Wylfa Newydd Project

Horizon's Deadline 8 Responses to Actions set in Issue Specific Hearings on 4 - 8 March 2019

PINS Reference Number: EN010007

25 March 2019

Figure 2-1 Section through mound D & E

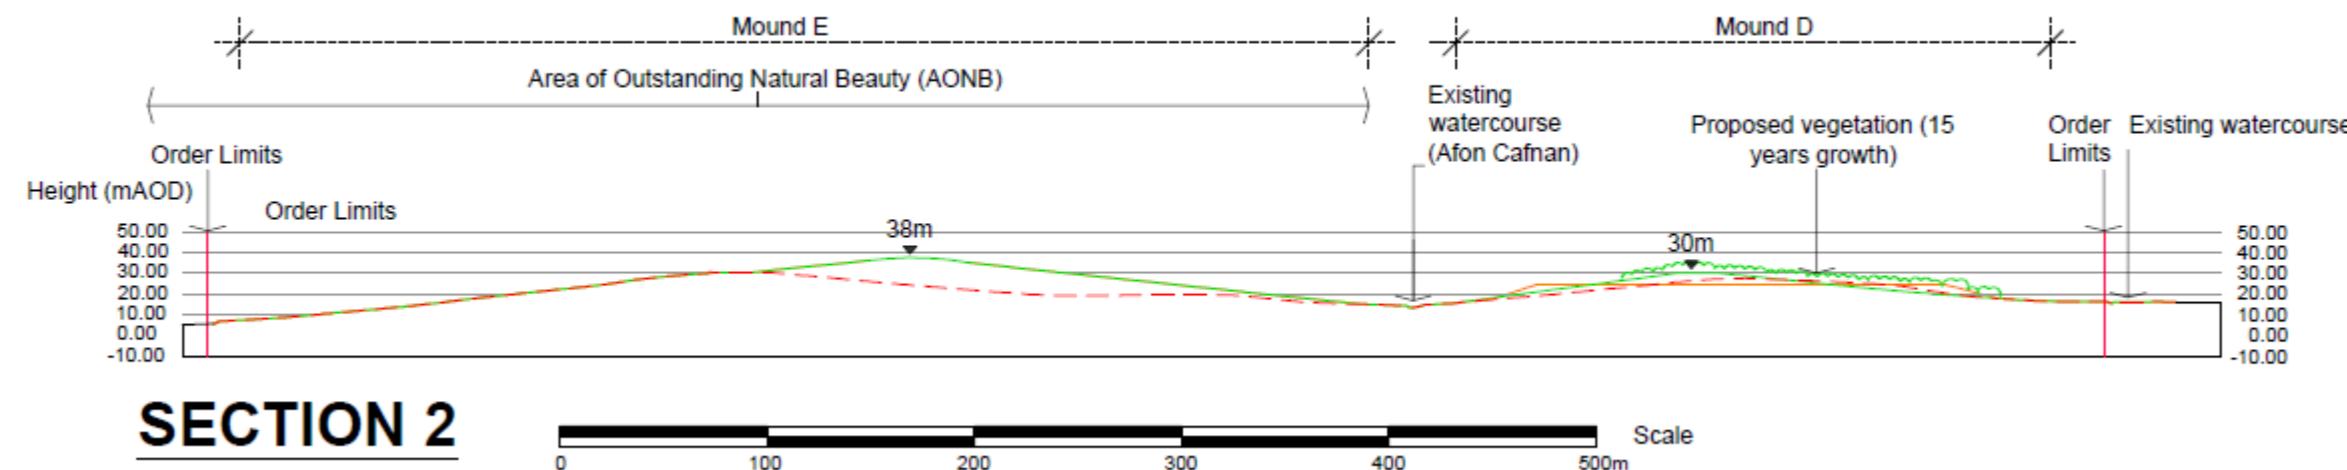
5	Mound E, which is entirely in the Area of Outstanding Natural Beauty (AONB), separates the power station site from the AONB. Providing screening for properties, National Trust (NT) believe the mound should not be reworked – at least on western facing slopes. This would give planting time to establish and	D7	Please refer to Appendix 1-1 of this document.

- 1.1.1 Mound D area during construction will be profiled to form a Laydown area for the construction of the Power Station as shown in the reference point drawing WN0902-HZDCO-LFM-DRG-00003, contained within the updated Wylfa Newydd Development Area and Power Station Site Plans submitted at Deadline 8. This area will be formed using a cut and fill construction methodology as outlined in the Construction Method Statement [REP5-018] recognising any specific environmental constraint associated with the adjacent Afon Cafnan water course.

- 1.1.3 The laydown area and power station levels during construction are defined by parameters in WN2 of Schedule 2 in the draft Order. The relevant parameter zones shown on the Power Station Site Construction Parameter Plan WN0902-HZDCO-MSP-DRG-00008, contained within the updated Wylfa Newydd Development Area and Power Station Site Plans submitted at Deadline 8. Zone C5 covers the laydown area with a maximum parameter of 35m AOD but is illustrated as 24.5m AoD.

- 1.1.4 The operational landform developed in accordance with the principles of the updated Landscape and Habitat Management Strategy (LHMS), submitted at Deadline 8, will be subject to further agreement under WN9 as part of the final detailed design; however, the illustrative proposal is shown in the reference point drawing WN0902-HZDCO-LFM-DRG-00005, contained within the updated Wylfa Newydd Development Area and Power Station Site Plans submitted at Deadline 8. This shows the power station platform at both 18m and 21m AOD with a peak to the final landform of circa 30m AoD for Mound D.

- On completion of power station construction remove Mound D laydown area and reprofile with material recovered from Mound E
 - Some of the quantity of soils stored at Mound E will be required for backfilling of Mound D on the WNDA to raise the power station construction platform to finished levels of circa 30m AOD. As shown on

Figure 1-1 Illustrative section of the construction landform opposite Tregele

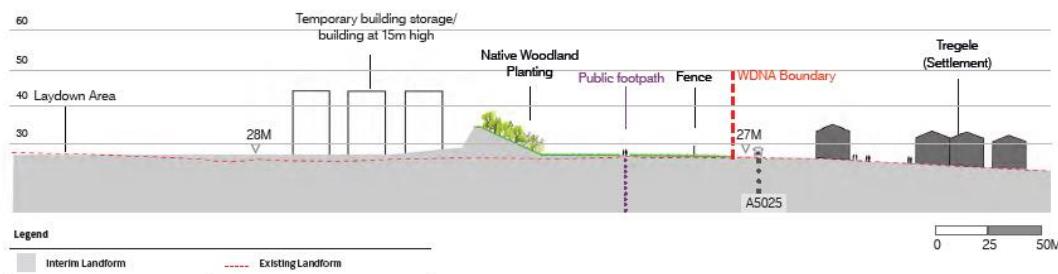
- 1.2.4 During the Issue Specific Hearing on 4th March 2019, clarification was requested as to whether the 7m height related to the existing road level of the A5025 adjacent to the mound or the proposed level of the adjacent laydown area to the west. Clarification was also requested on the maximum parameter height for construction of this landform. A response to both these matters is set out below.

- 1.2.12 It is intended that the lower portion of this screening landform will form part of the permanent Mound B and be constructed up to 7m above A5025 road level and planted early during construction, whilst the upper part of the construction landform above the 7m height will be a temporary landform, seeded with grass and set back beyond an intermediate crest in order to reduce its visual prominence. In order to achieve a height 7m above laydown level, where this would equate to over 10m above A5025 road level in some locations, the localised use of environmental barriers up to 2m height could be considered to limit the height of the construction landform.

Figure 1-4 Extract of illustrative plan of final contours

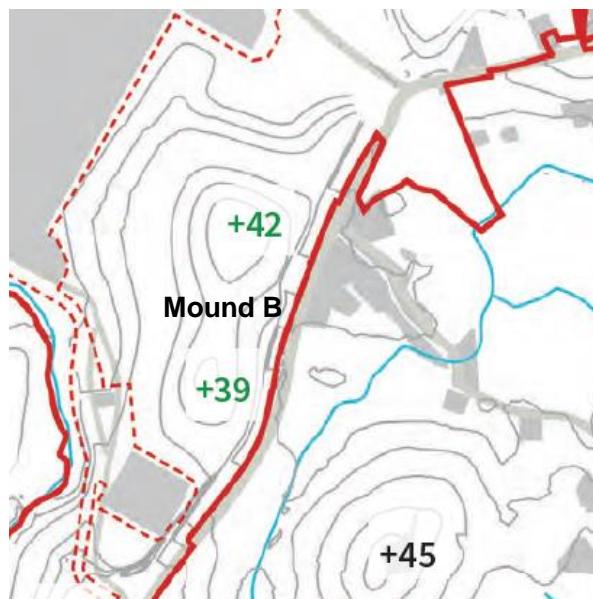
- 1.1.2 This document provides a response to a question raised by the Examining Authority during the Development Consent Order (DCO) Issue Specific Hearing 4th March 2019, regarding the level of Mound B west of Tregele, relative to the laydown area level and A5025 level during construction. For completeness, this document also clarifies the final form of Mound B.

- 1.3.1 As explained in paragraph 6.3.14 of the Landscape and Habitat Management Strategy, submitted at Deadline 8 (25 March 2019), Mound B shall be reworked following completion of construction activities, to form the final contours of the landscape mounding on the former laydown area adjacent to the A5025. This is shown indicatively on figure 6-6 of the Landscape and Habitat Management Strategy and the corrected Wylfa Newydd Development Area reference point drawing 5, Rev 4.0 within Wylfa Newydd Development Area and Power Station Site Plans (Part 1 of 2), both as submitted at Deadline 8, which indicates that Mound B will gradually rise to approximately 42mAOD opposite Tregele, as illustrated in the extract on figure 1-4 below. This reworked landscape mounding will incorporate the lower 7m height of the landform implemented and landscaped early during construction without the need to remove any part of the early planting. The upper part of the construction landform above this level (7m above A5025 road level) will be re-profiled to achieve a more gentle natural profile in keeping with the surrounding drumlin landforms. As such, the final landscape mounding for Mound B would be as indicated on the supplementary operational photomontage from Viewpoint 18 (appendix D10-A of the ES Addendum, Supplementary community views assessment, Addendum to appendix D10-8 – Photomontage views [REP6-016]), as reproduced in annex 1-2 of this document.

Figure 1-1 Nitrogen deposition at Cae Gwyn SSSI

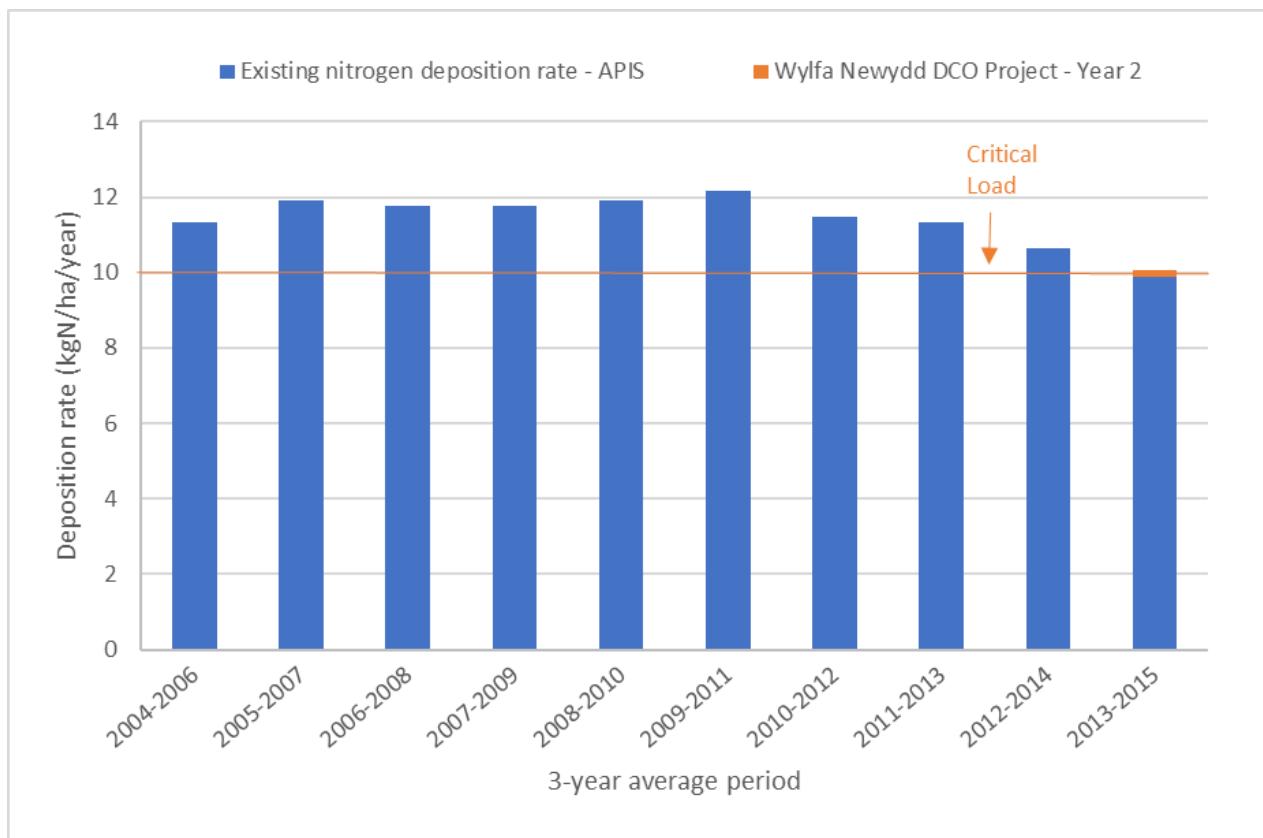
***Recorded at 8th March ISH: Post hearing note on REP5-022
oxide monitoring regarding Cae Gwyn SSSI; NRW REP4-039
bog habitat response needs to be reviewed and resubmitted
at DL8***

- 1.1.8 The conclusion of a minor adverse effect is further supported by considering the magnitude of the predicted increase in nitrogen deposition due to the emissions from the construction activities against fluctuations experienced in the existing deposition rates on an annual basis. Figure 1-1 shows the existing nitrogen deposition rates (presented as three-year averages) for Cae Gwyn SSSI (data obtained from the Air Pollution Information System (APIS) website). The 2013-2015 three-year average (the latest dataset available) was adopted as the existing deposition rate for the assessment as agreed with NRW (see appendix B5-2 [APP-084] of the Environmental Statement). Figure 1-1 shows graphically the scale of the predicted increase in nitrogen deposition of 0.16 kgN/Ha/year at the southern basin of the Cae Gwyn SSSI for the year 2 scenario. It is noted that the increase due to the Wylfa Newydd DCO Project is considerably smaller than the variations in existing nitrogen deposition experienced in the last 10 to 15 years at Cae Gwyn SSSI. The increase from the 2004-2006 period to the 2009-2011 period was 0.9 kgN/Ha/year, which is approximately 8 times higher than the average predicted increase at the southern basin due to the construction of the Power Station.

- 1.1.9 Whilst Horizon recognises the general point which NRW makes, that species richness does not necessarily equate to species value, the predicted changes in species richness of 0.2% and 0.1% are considered low enough to allow a robust conclusion to be made of the magnitude of potential change to the receptor. Given this, and the information presented above, Horizon considers its conclusion of potential minor adverse effects to Cae Gwyn SSSI as a result of changes in air quality to be precautionary, and is therefore appropriate.

Annex 1-1 Reference point 6 Drawing

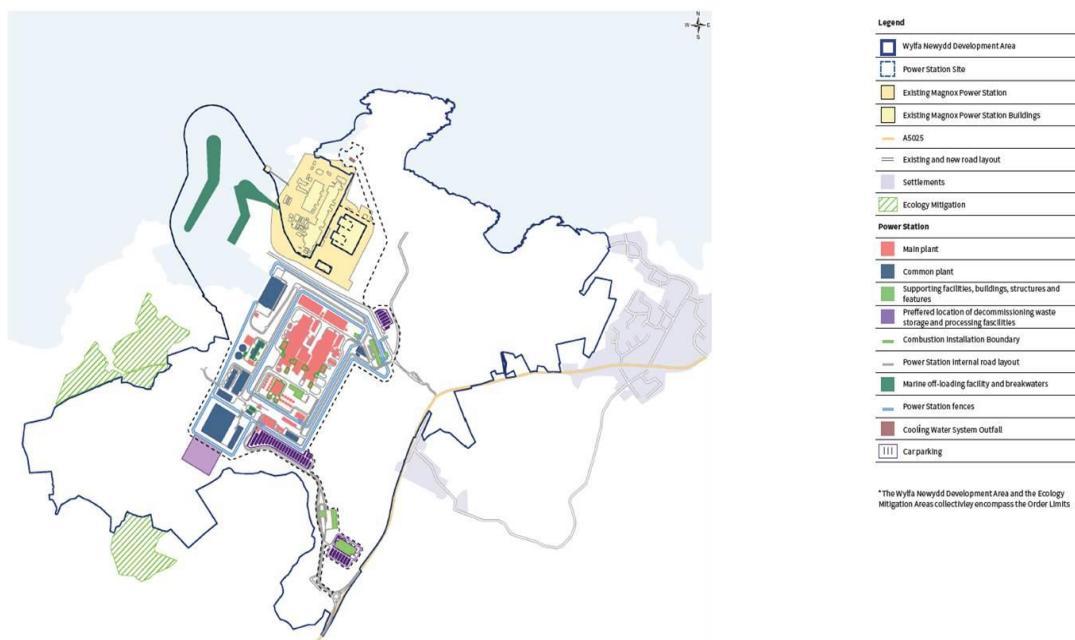
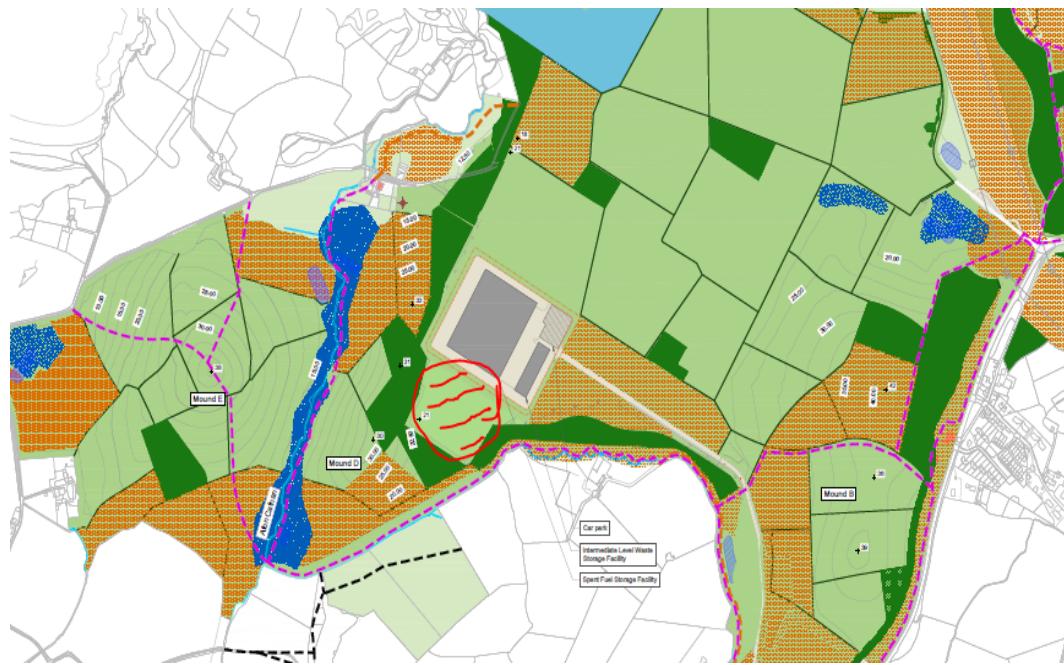
29	Applicant will check purple area in D & A Statement re Spent Fuel and Intermediate Level Waste Storage buildings. Applicant to demonstrate how these buildings would be serviced in long term	Wednesday	Please refer to Appendix 1-11 of this document.
30	Applicant to provide an illustrative drawing of Spent		Please refer to Appendix 1-11 of this document.

1.1.4 A post-decommissioning drawing has therefore been prepared to illustrate the WNDA reference point (reference point 6), following completion of the main decommissioning activities but with the Spent Fuel Storage Facility and ILW Storage Facility shown as retained. However, the post-decommissioning drawing does not show the Fuel Repackaging Facility, as it does not form part of the DCO application. A potential location for the Fuel Repackaging
